SUBJECT: Savannah River Site's Responses to the Regulatory Comments on the Facility Decommissioning Evaluation D-Area Domestic Water Production Facilities (Building 483-7D and Ancillary Facilities) (G-FDE-D-00052, Revision 0, June 11, 2020) Simple Model

Savannah River Site Responses to
ENVIRONMENTAL PROTECTION AGENCY
Comments on the
FACILITY DECOMMISSIONING EVALUATION FOR
BUILDING 483-7D, D-AREA DOMESTIC WATER PRODUCTION FACILITIES
G-FDE-D-00052, Revision 0, June 11, 2020

Savannah River Site Responses to
SOUTH CAROLINA DEPARTMENT OF HEALTH AND ENVIRONMENTAL CONTROL
Comments on the
FACILITY DECOMMISSIONING EVALUATION FOR
BUILDING 483-7D D-AREA DOMESTIC WATER PRODUCTION FACILITIES
G-FDE-D-00052, Revision 0, June 11, 2020
Cover Letter Dated June 25, 2020 / Comments Received on July 24, 2020

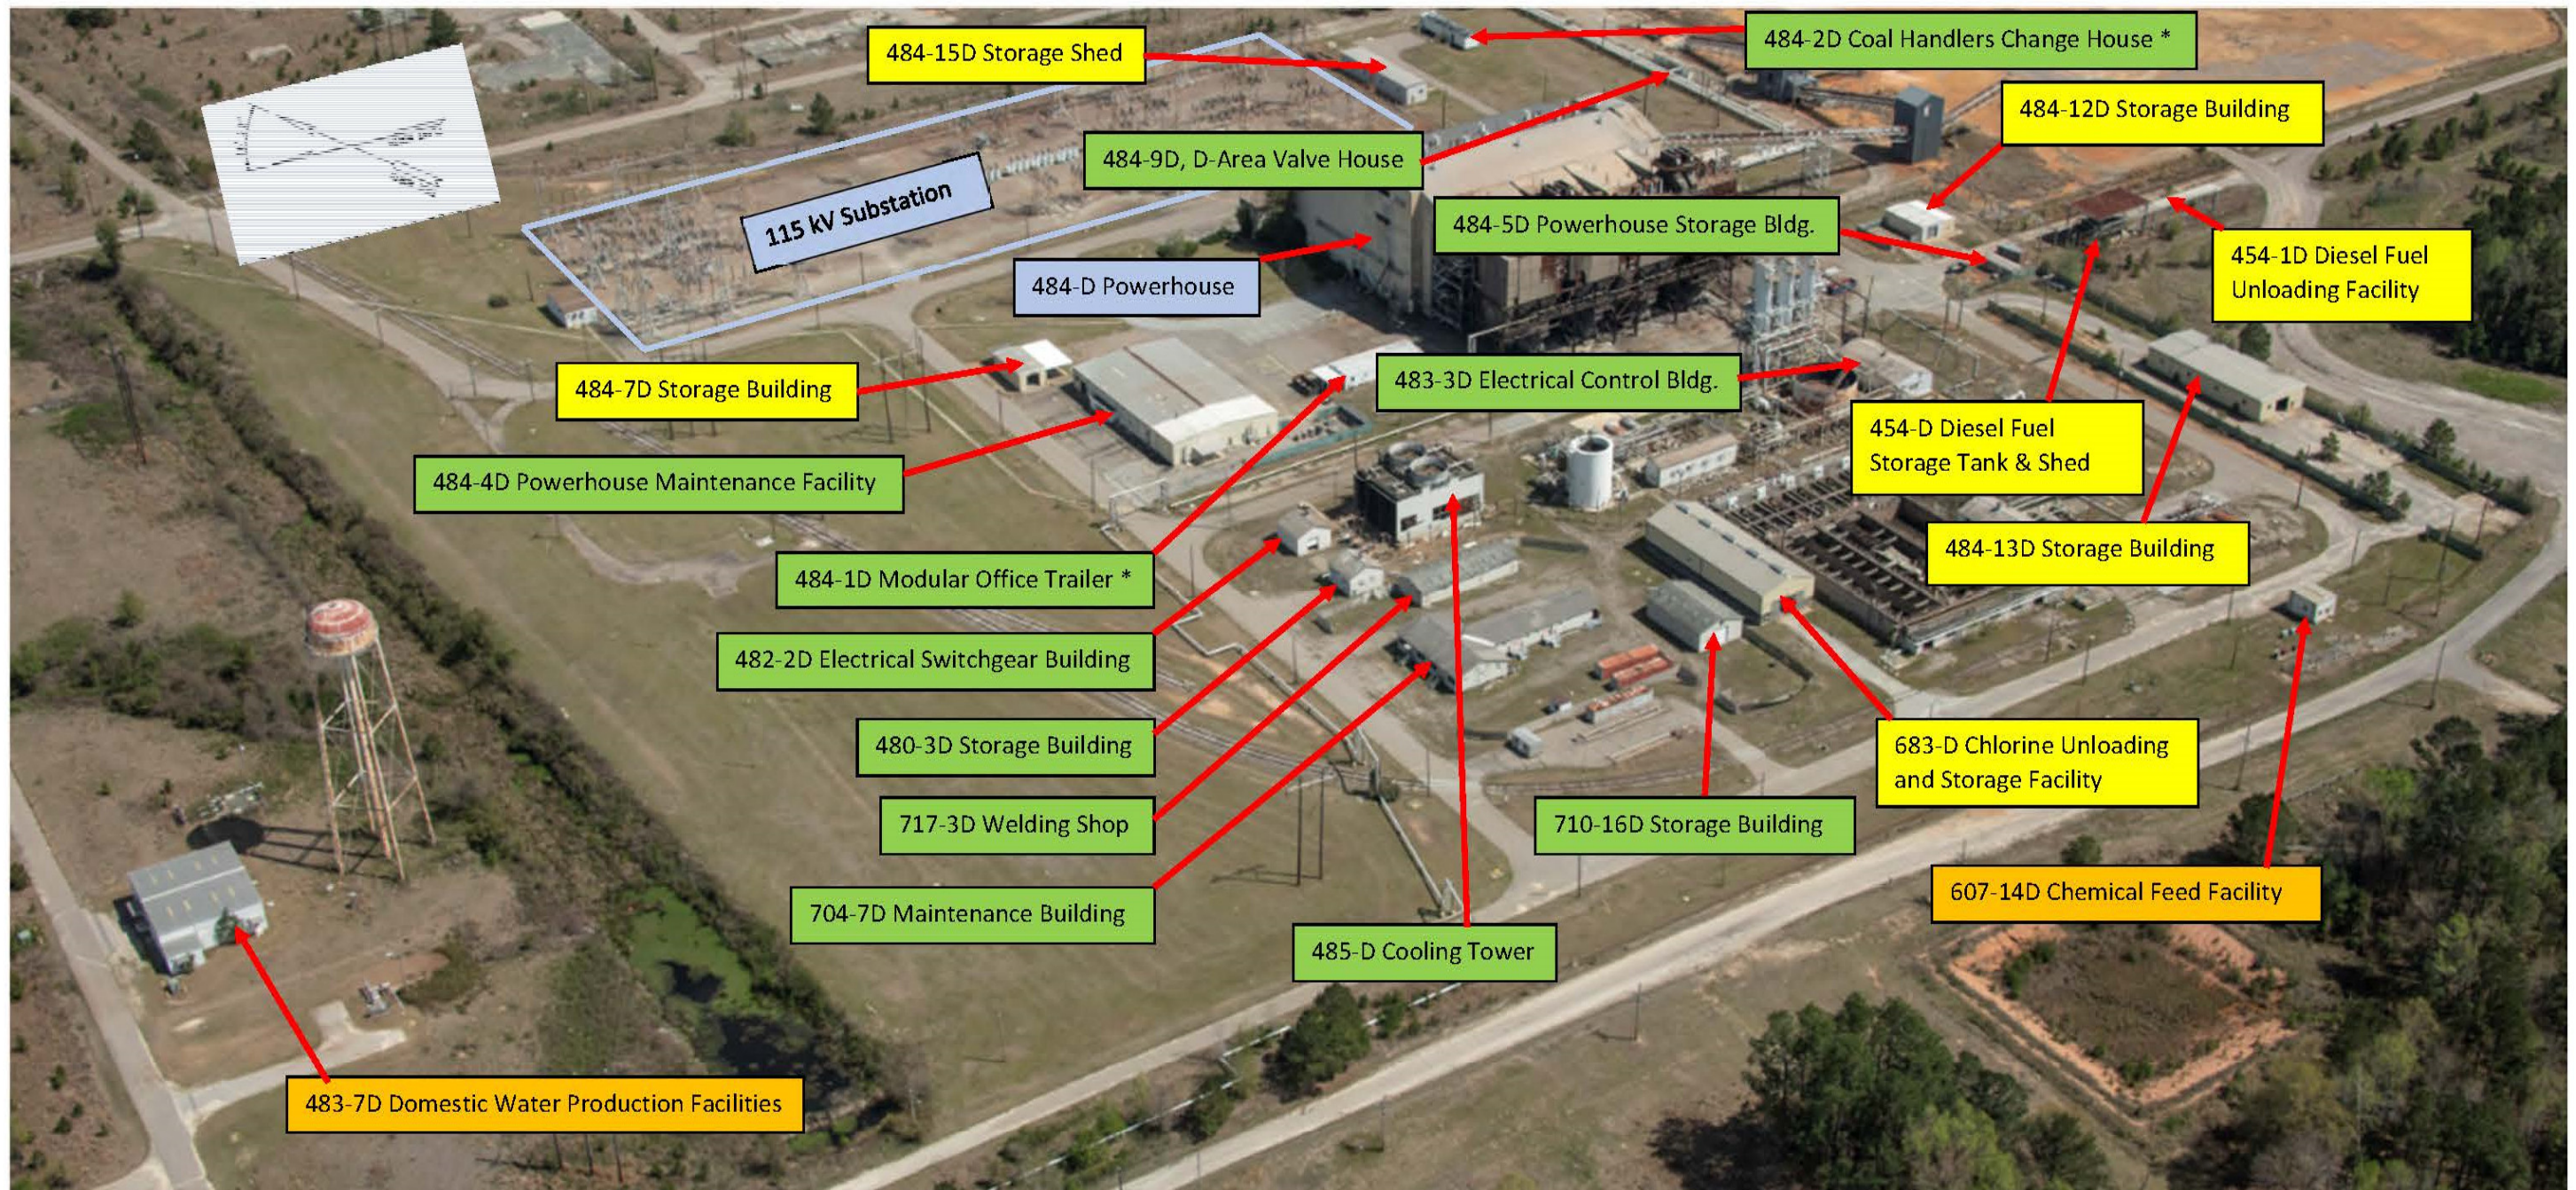
- d. Please include information within the FDE or modify Figure to depict if the Sodium Hypochlorite, Polyphosphate, Soda Ash and Potassium Permanganate Tanks/Pumps have any associated above or below grade plumbing.
 - i. Please include any associated piping's final disposition for either above or below grade plumbing that may be present.

Response to 10) c. and i: Clarification.

SRS has reviewed the request for details on the above listed items concerning above and below grade piping/ plumbing. The details requested are best shown on the as-built drawings listed below. PDFs of the drawings are included with these responses

1. W2013063, dated Dec.'91: "Chemical Feed Systems & Building, Floor Plan and Elevation"
2. W2013068, dated Dec. '91: "Chemical Feed Systems & Building, Chemical Feed Piping Plan Sections & Details"
3. W2013069, dated Dec. '91: "Chemical Feed Systems & Building, Piping Sections"
4. W2013070, dated Dec. '91: "Chemical Feed Systems & Building, Chemical Feed Piping Plan and Sections"
5. W2013072, dated Dec. '91: "Chemical Feed Systems & Building, Plumbing Plan"

PRIMARY DOMESTIC WELL

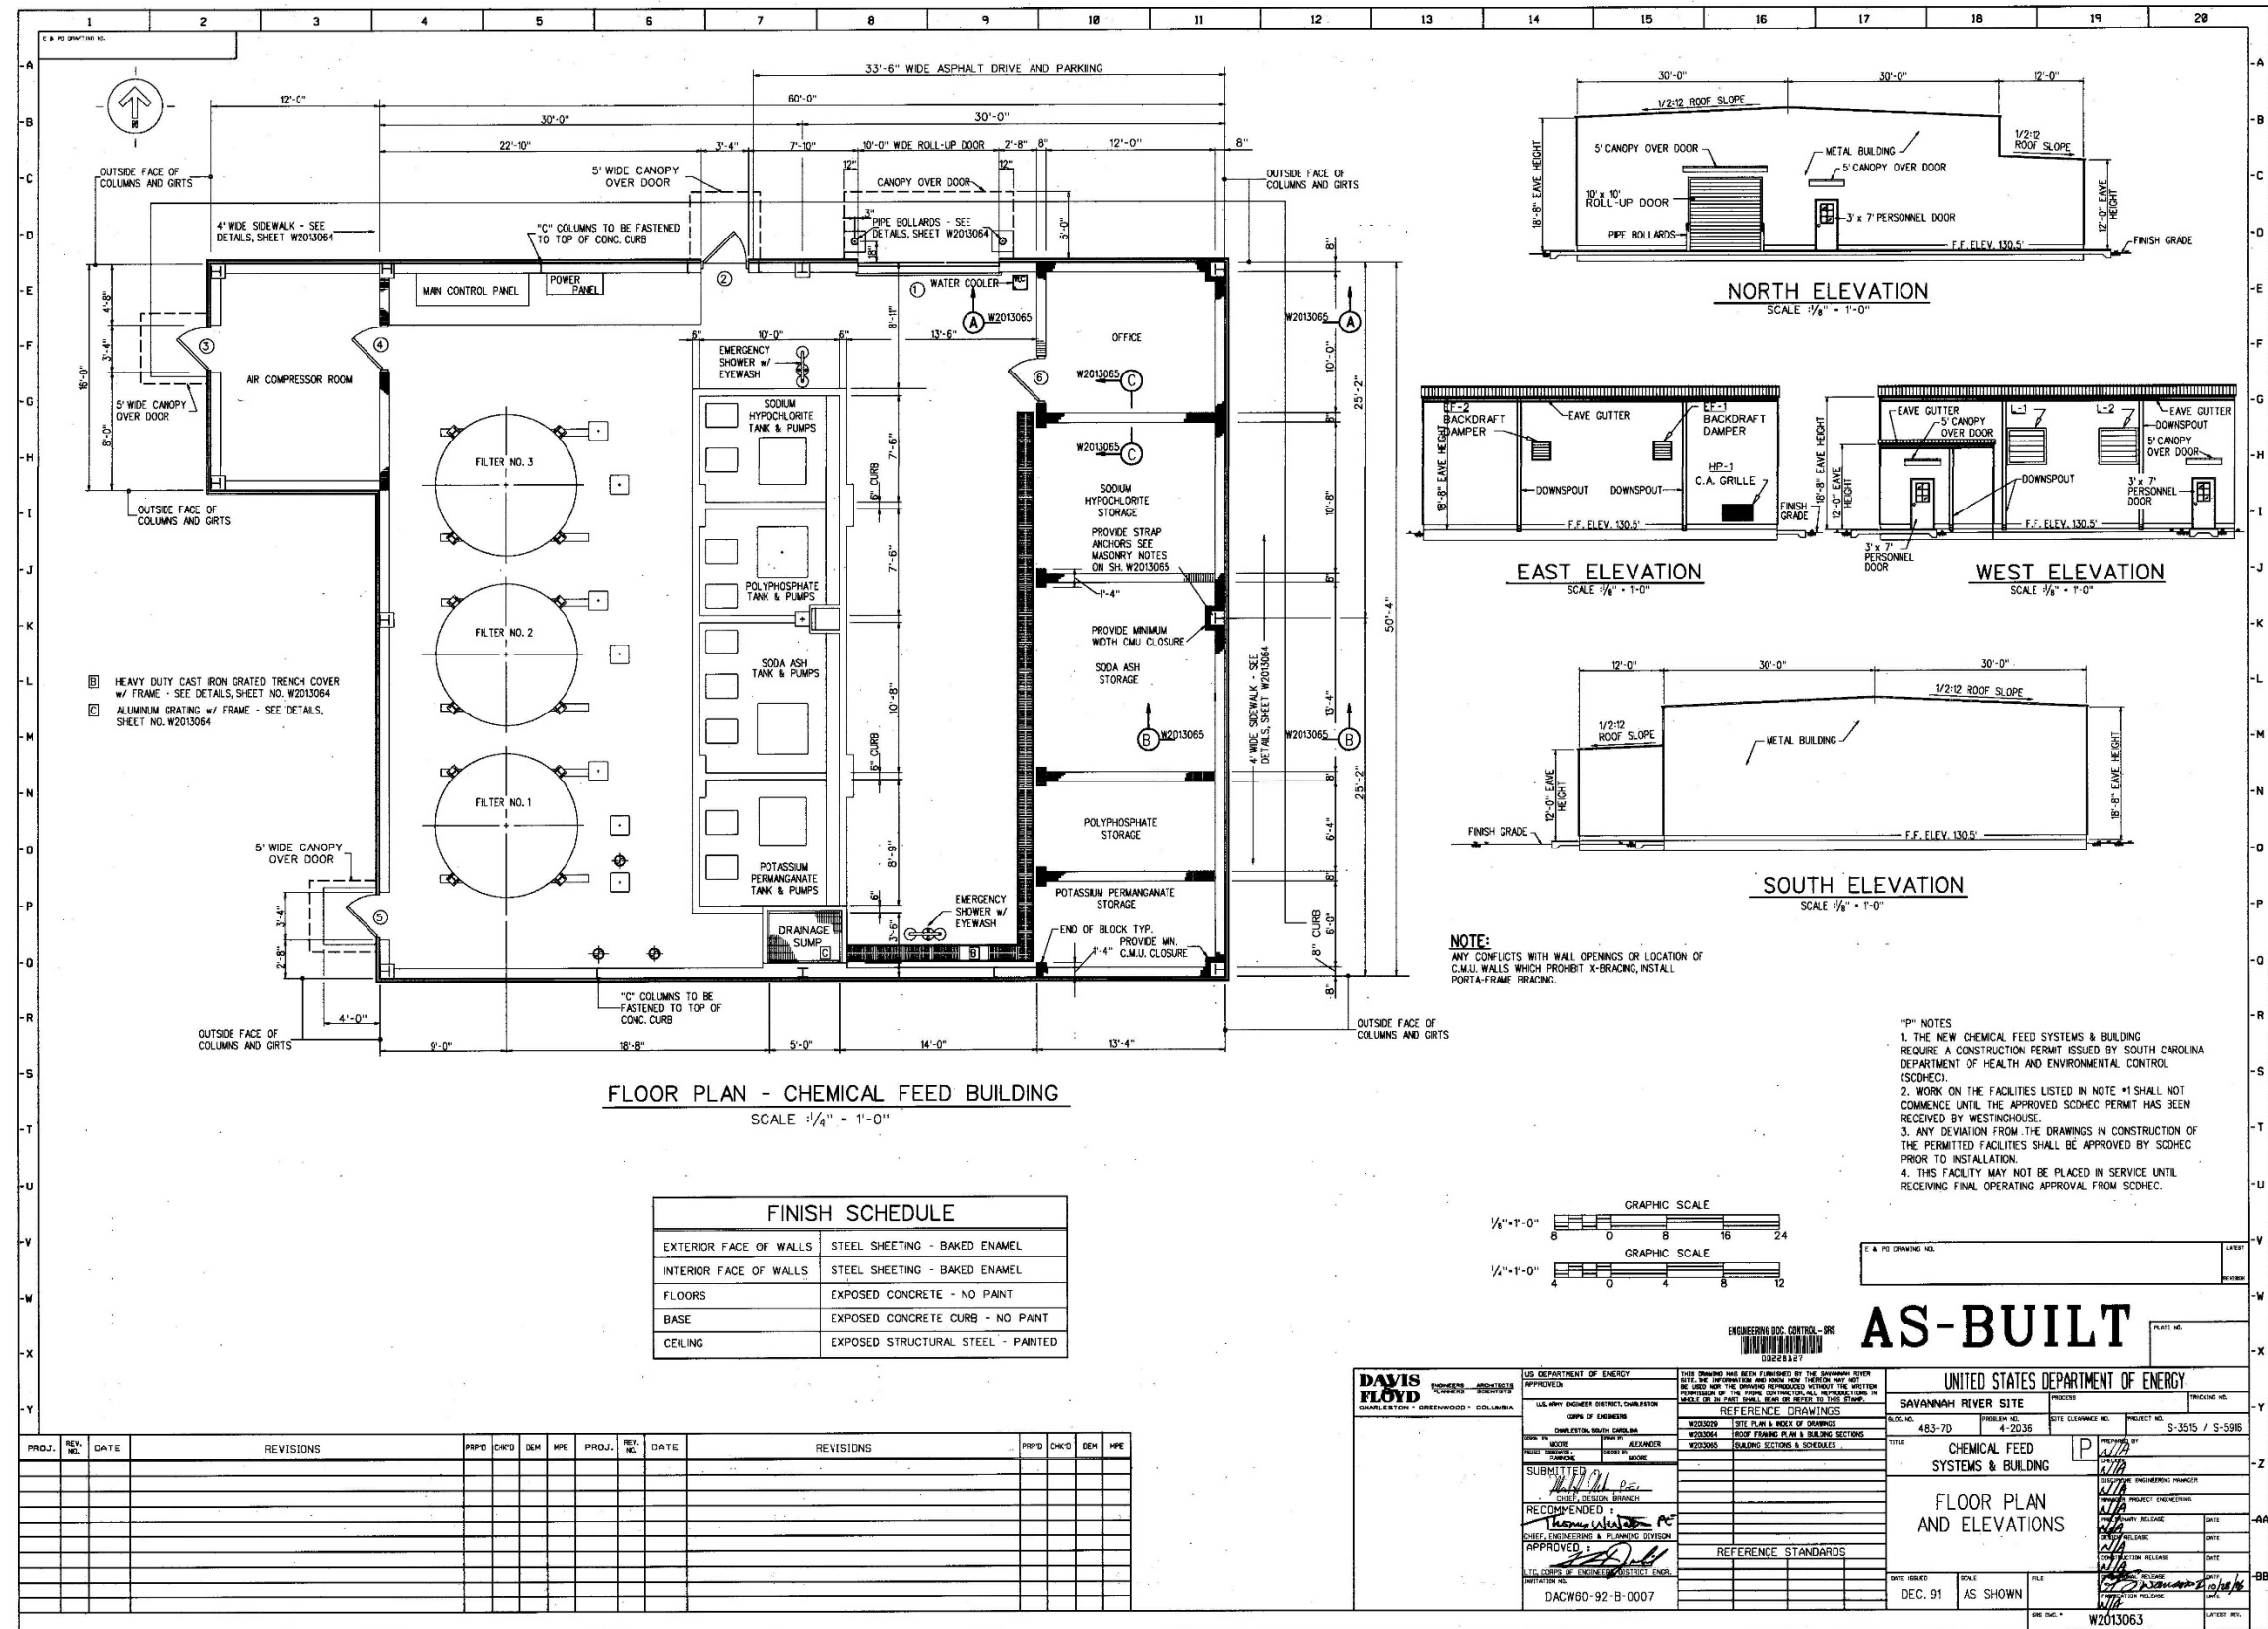
- 6) **Part 1. Project Scope:** Please include well construction details for the Primary Domestic Water Well (905-3D, TD of 740 feet) and the Back-up Domestic Water Well (905-136D, TD of 765 feet).

Well construction details are provided on drawing W2013033 for Primary Domestic Well 905-3D and drawing W2013034 for Backup Domestic Well 905-136D. Both drawings are included with these responses.
